APPLICATION FOR PERMISSION UNDER SECTION 16 OF THE TOWN PLANNING ORDINANCE (CAP.131)

For Official Use Only 請勿填寫此欄	Application No. 申請編號	A / N7-F7A / 201
	Date Received 收到日期	18 DEC 2020

Hong Kong Chilled Meat & Poultry Association 香港冰鮮家禽業商會

PlanPlus Consultancy Limited

Figure 3-2: Indicative Proposed Drainage Layout

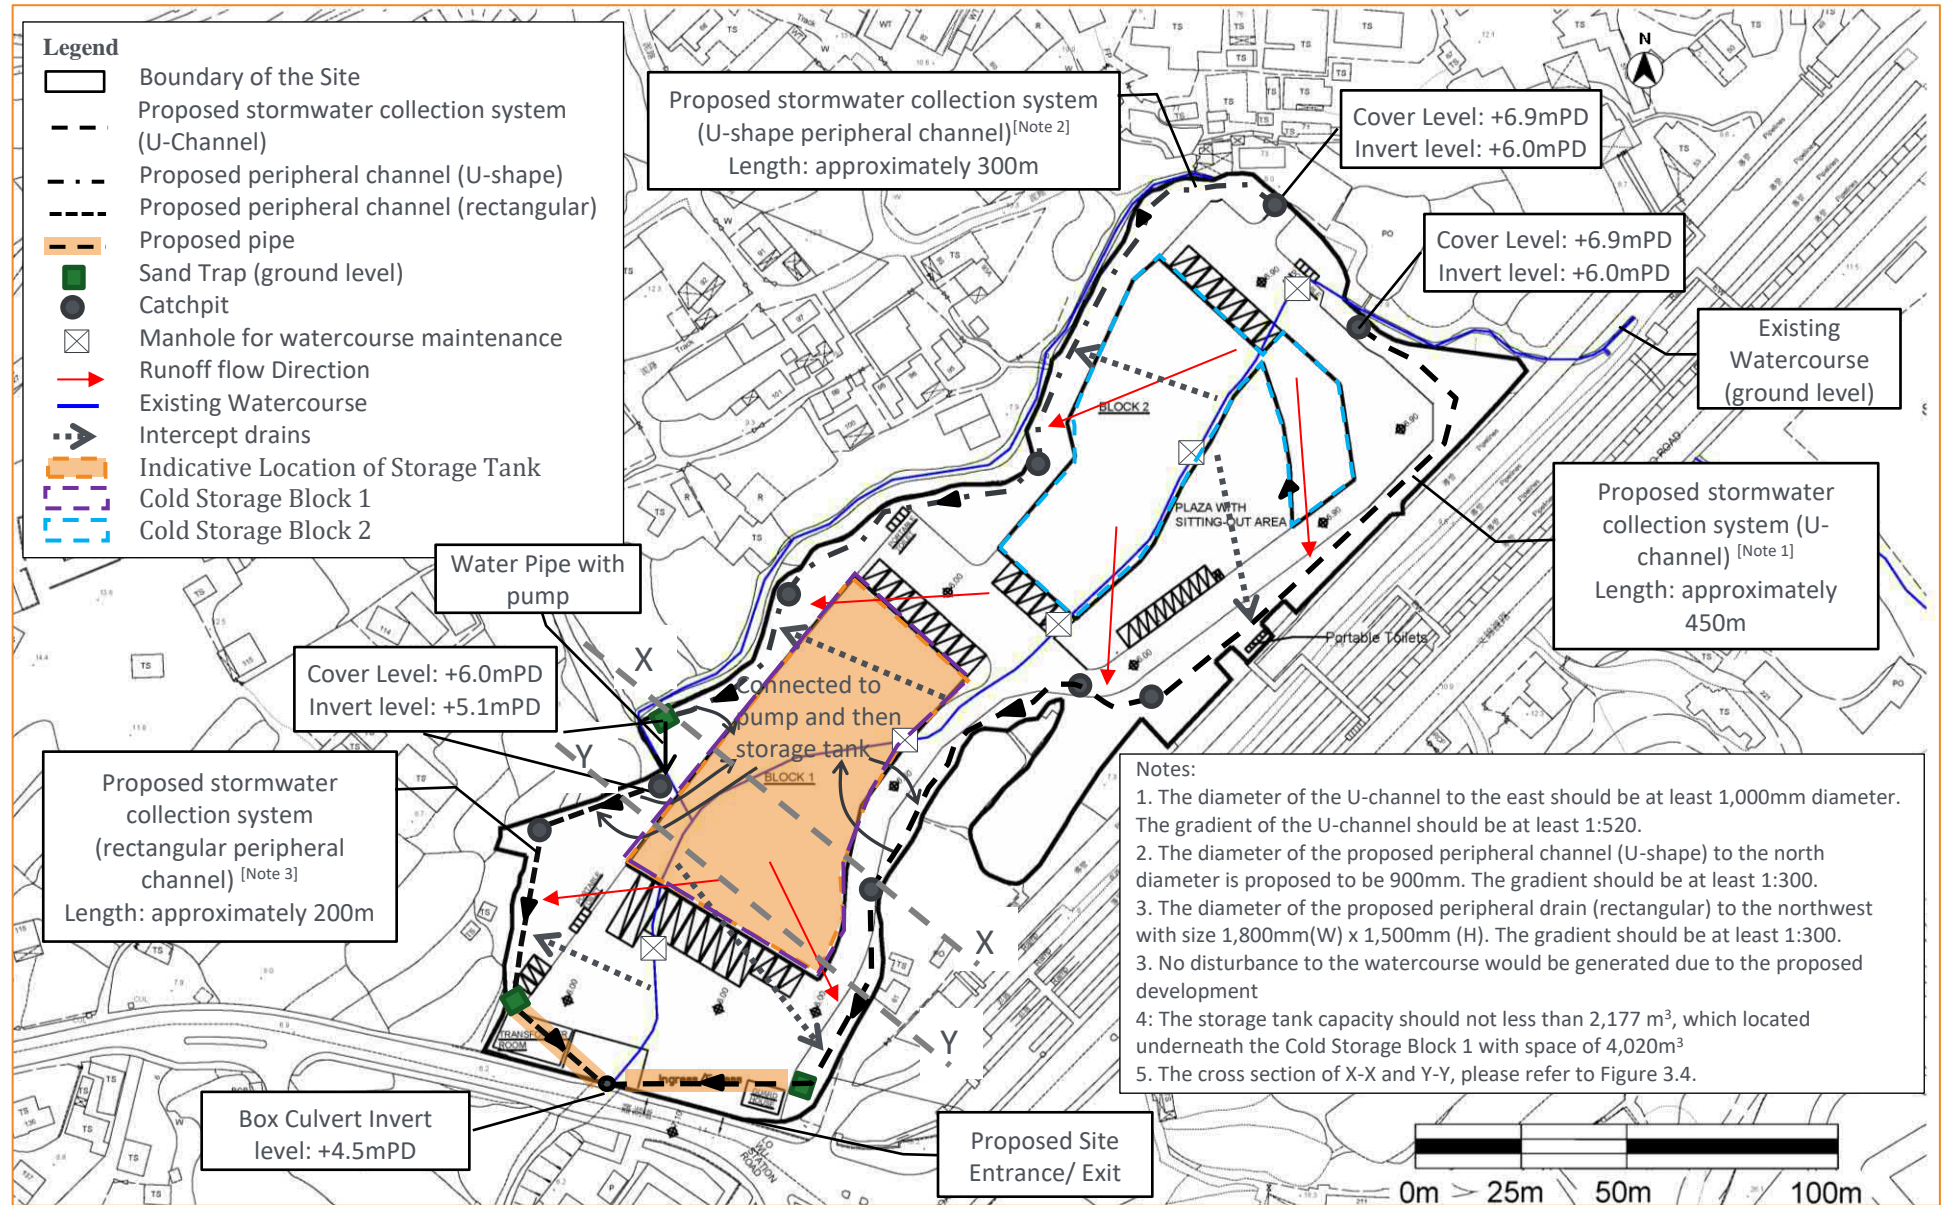
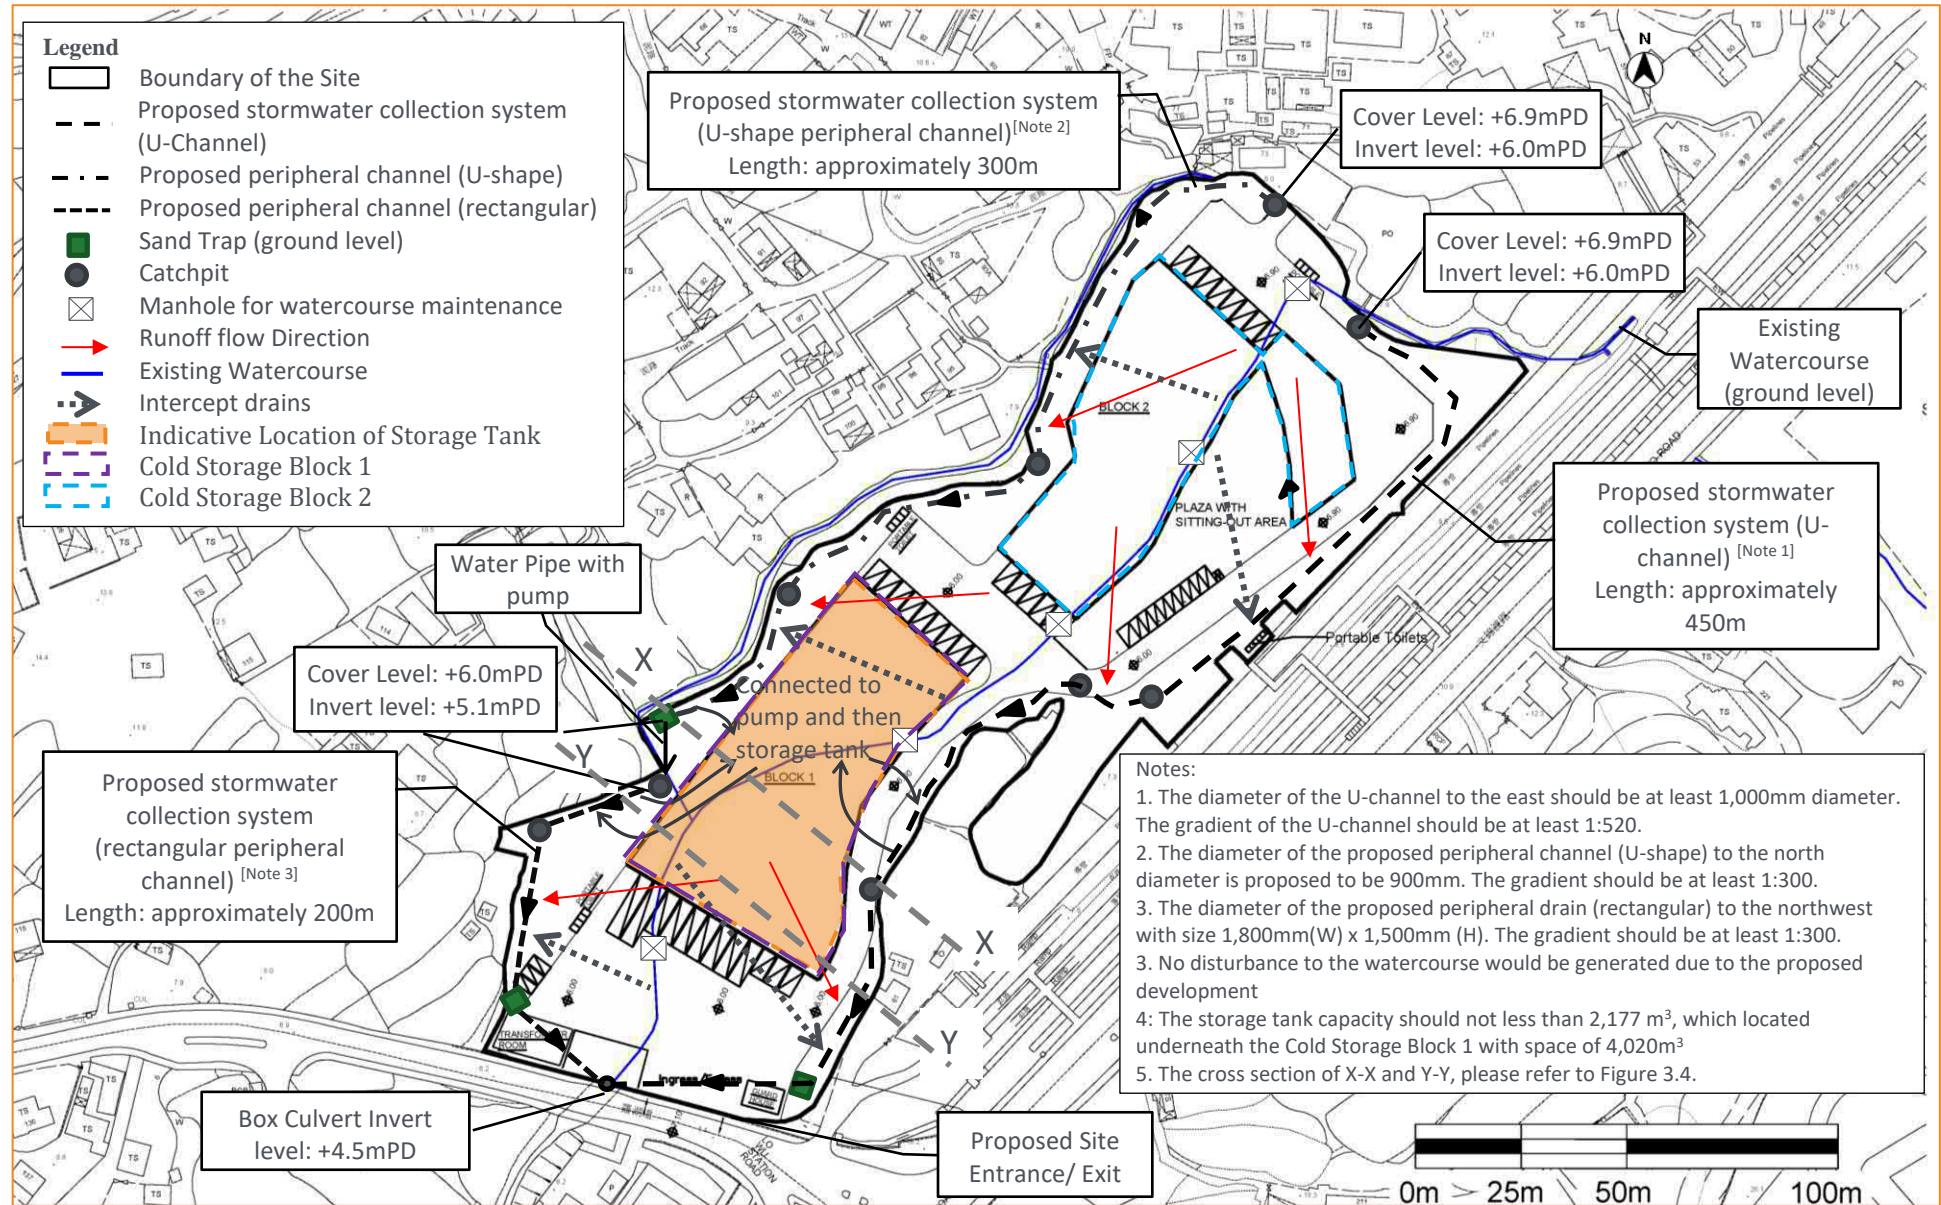
Date	Department	Comments	Responses
21.1.2021	EPD	1. Figure 3.2 of Drainage Impact Assessment at Annex 8 - We note that the starting and discharge points of the proposed U-channel are close to that of the watercourse running across the site (i.e. main watercourse). Besides, we understand that an aboveground stormwater storage tank would be provided, and no information of its location has been provided.	The stormwater storage tank will be located in the space beneath the cold storage building and above the ground tentatively. The actual size and location of the tank will be subject to the detailed design stage in the future. Aforementioned information has been added in Section 4 of the revised EA report.

C. The applicant should clarify whether drainage diversion, as stated in the caption of the figure, would be carried out. If affirmative, the relevant details should be provided.	No drainage diversion of the existing watercourse will be involved in the Project. Figure 3.4 has been provided to show the level difference of proposed drain and existing watercourse. The title of Figure 3.2 of the DIA Report has been revised, footnote has been provided as well.

6. <u>Annex 8 Drainage Impact Assessment - 8.3.4.1 and Figure 3.2</u> : It is noted an on-site storage tank is proposed to store the runoff and the surplus runoff will be drained off to the proposed u-channel. According to Figure 3.2, it seems the water from the upstream section of the existing water channel are diverted to the proposed u-channel and it is unclear whether such diversion will reduce water flow in the existing water channel. Please advise if the water flow in the existing water channel will be affected by the proposed storage tank and u- channel.	There is no connection between the internal drainage system and the existing watercourse at the upstream section. No diversion of the existing water channel will be required and thus no reduction of water flow will be occurred. The internal drainage system will be connected to the existing water channel only at the proposed outfall at the downstream location at the southwestern boundary of the Application Site.

Date	Department	Comments	Responses
11.5.2021	DSD	Figure 3-2	
		1. The details (invert level, gradient, etc.) of the proposed drain/surface channel, catchpits and the discharge structure shall be provided. Particularly, the cover level and invert level of every catchpit and manhole, and the size of the existing watercourse should be specified.	<p>The cover levels and invert levels at some of the channels have been indicated on Figure 3-2 (<i>Refer to the enclosed replacement pages</i>).</p> <p>The detailed cover levels, invert levels, sizes and gradient of each drain including the existing watercourse, and other details will be provided in the Drainage Proposal, should the current planning application be approved by the TPB. The Drainage Proposal will be prepared by a qualified engineer to the satisfaction of the drainage authority and the other government departments as mentioned in para. 4.1.6 of the DIA.</p>

2. Please ask the applicant to clarify whether the levels indicated in Figure 3-2 are invert levels of drains or formation levels.	The levels have been clarified that both cover and invert levels of the drain/channel have been shown on Figure 3-2.

3. General information of the site such as topography, fall direction, formation level, position of buildings or structure, landscaping area, proposed drain/surface channel, catchpits, storage tank, etc., should be indicated <u>on the same plan</u> . Please ask the applicant to combine Figure 3-2 and 3-3 for better illustration of the proposed development and the drains.	General information including the buildings position, fall direction, formation level and etc. have been indicated in Figure 3-2. Figure 3-2 and Figure 3-3 have been combined and renamed as Figure 3-2.

4. Please ask the applicant to specify the fall directions of the ground to the peripheral drains.	The fall direction has been indicated on Figure 3-2.

5. It is suggested to add a covered channel across the site between Block 1 and Block 2.	Intercept drains have been proposed and indicated on Figure 3-2.

6. Please ask the applicant to specify the manhole intervals of the existing watercourse. It seems that the proposed manhole intervals of the existing watercourse exceed the limit specified in the Stormwater Drainage Manual. Please ask the applicant to review.	The maintenance manhole interval of approx. 60m along the existing watercourse has been adopted. Please refer to the revised para. 3.4.13 and Figure 3-2 of the DIA for details (<i>Refer to the enclosed replacement pages</i>).

- 3.4.11 A series of stormwater collection system (i.e. internal U-channel) is proposed along the east part of site boundary in order to collect the runoff from the proposed elevated platform as shown on **Figure 3-2**. Furthermore, sand trap and cover will be provided to minimise sand/silt go into the drainage system.

- 3.4.13 There is an existing watercourse passing through the Site from north-east to south-west direction and then connected to the existing box culvert after connecting the other existing channel which located along the northern site boundary. Decked over the existing watercourse is proposed to minimise disturbance to it. Furthermore, manholes for watercourse maintenance are proposed along the existing watercourse with the interval of 60m, the indicative location of maintenance manholes as shown on **Figure 3-2**.

Figure 3-3: Section Plan of Proposed Drainage Layout

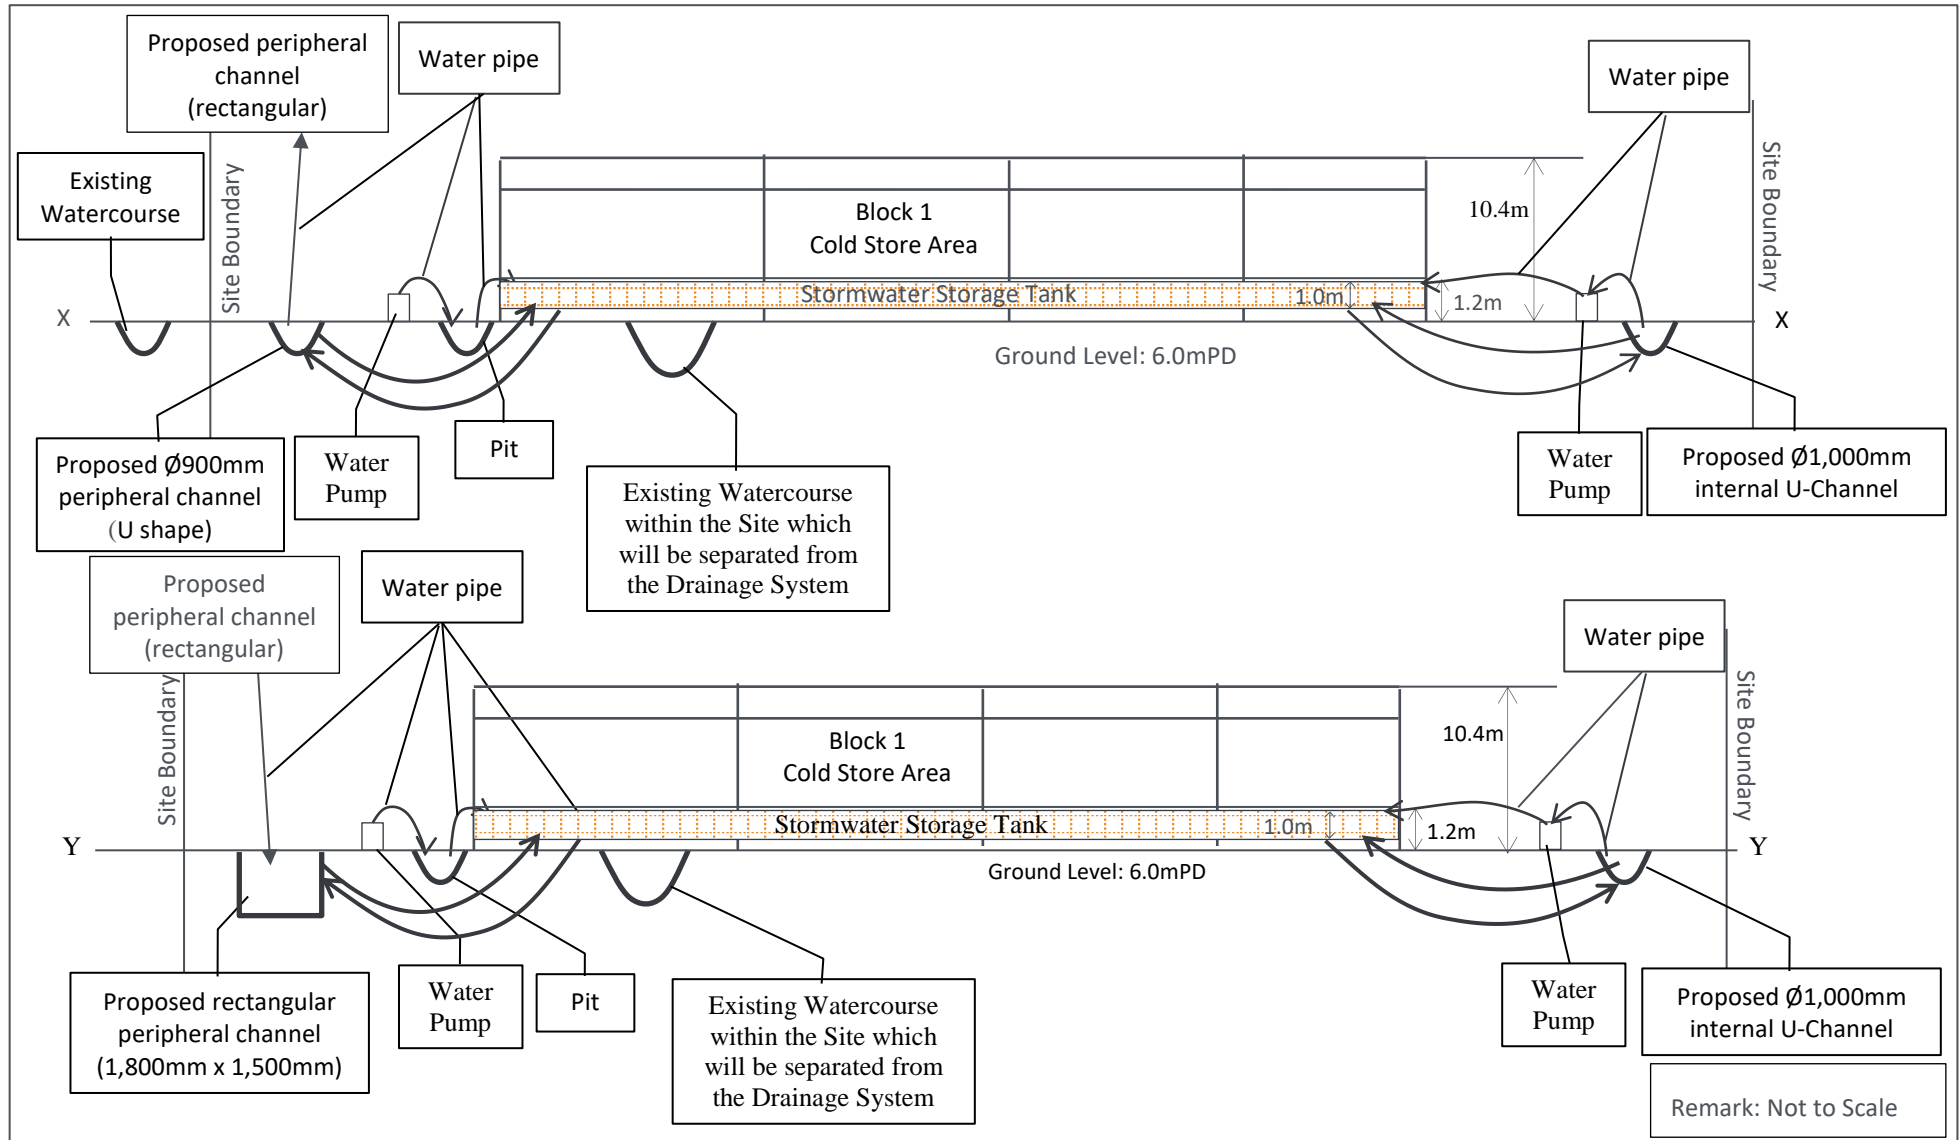
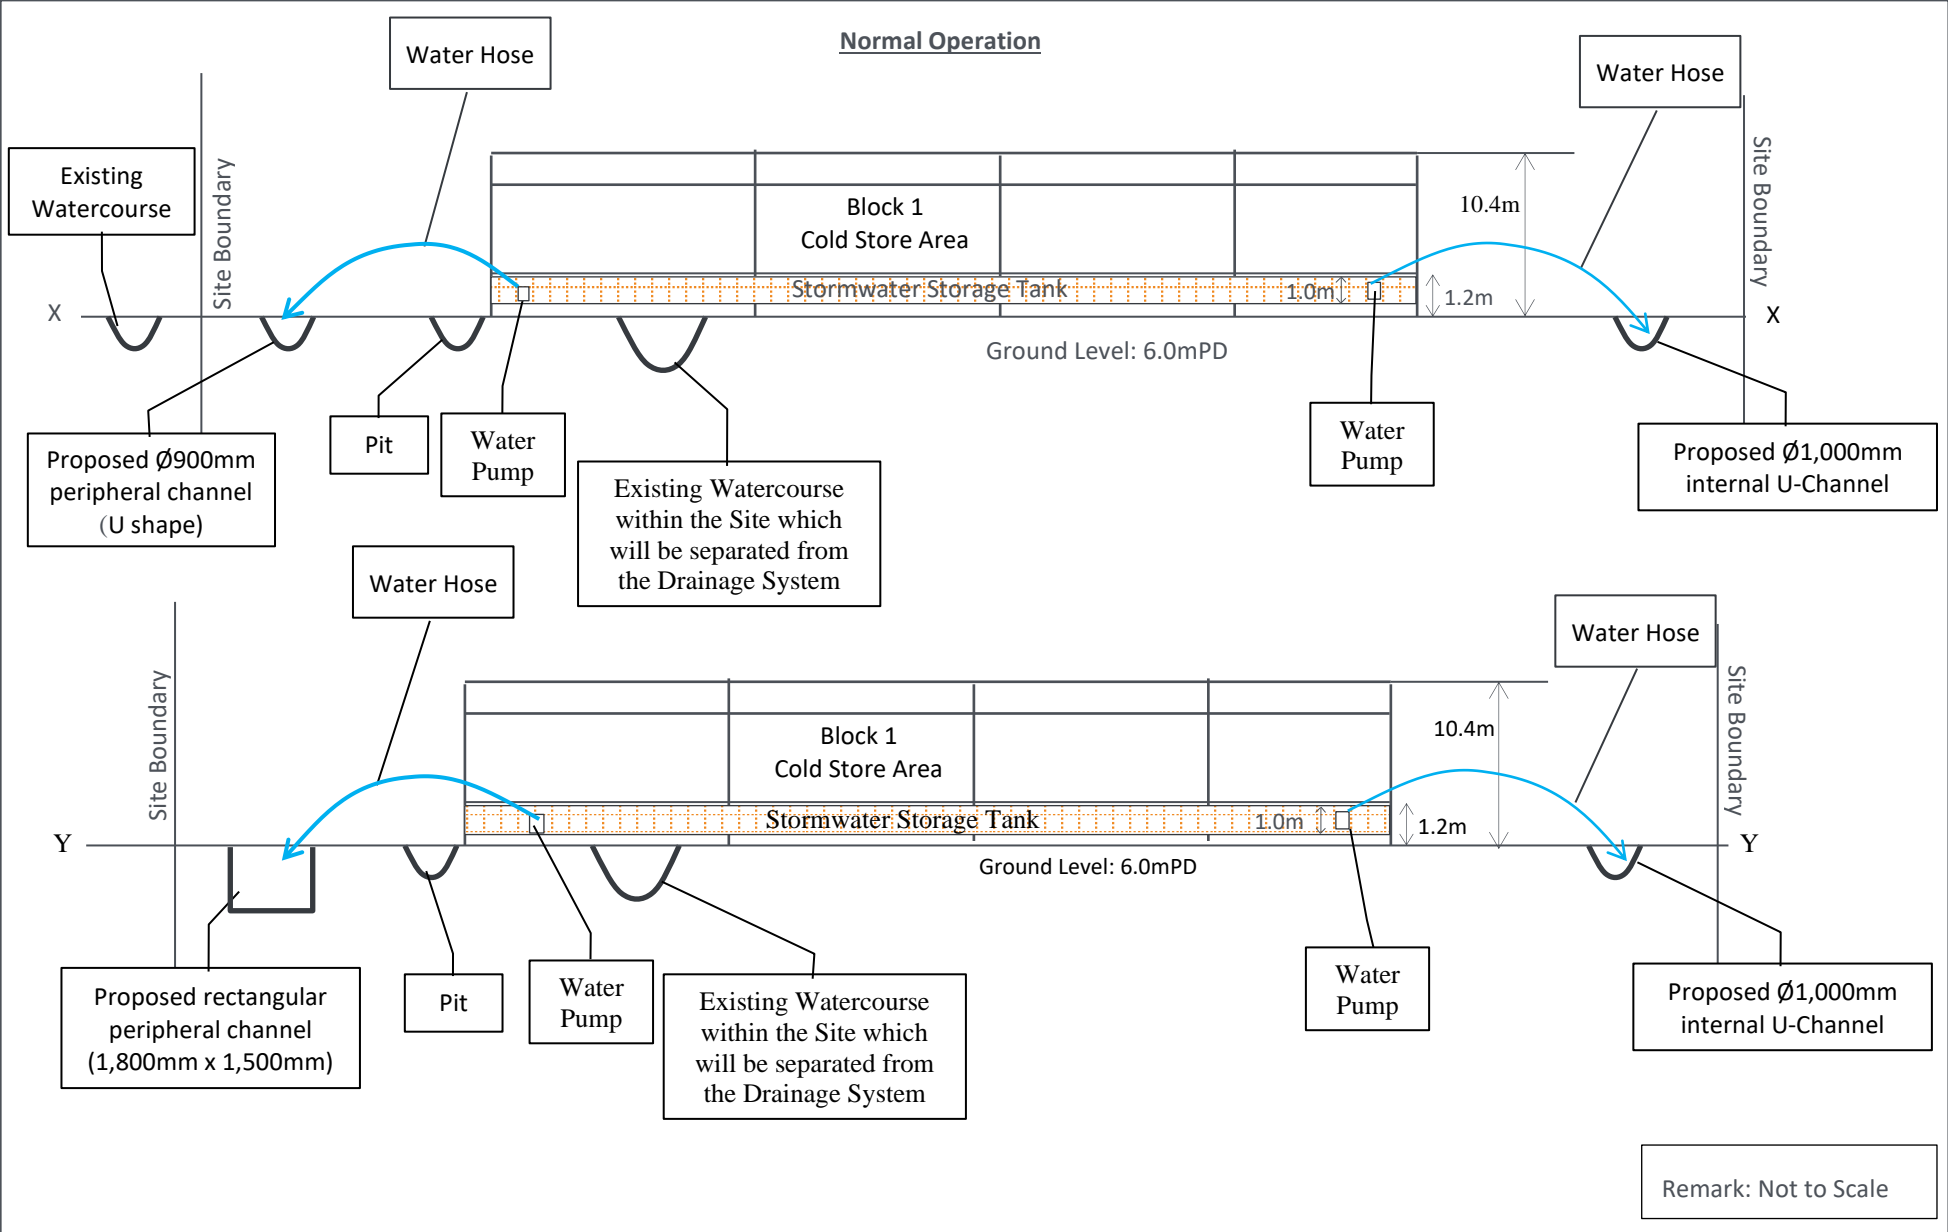
A. The location of the stormwater storage tank, if available, should be provided.	Please also refer to the revised Figure 3.3 of the DIA Report showing the indicative location of the stormwater storage tank.

10. Please ask the applicant to double check the size of the proposed rectangular peripheral channel in Section Y-Y.	Figure 3-3 has been revised (<i>Refer to the enclosed replacement pages</i>).
		General

- 3.4.17 The indicative section plan to show the elevation level of each proposed mitigation measures is provided on **Figure 3-3**.
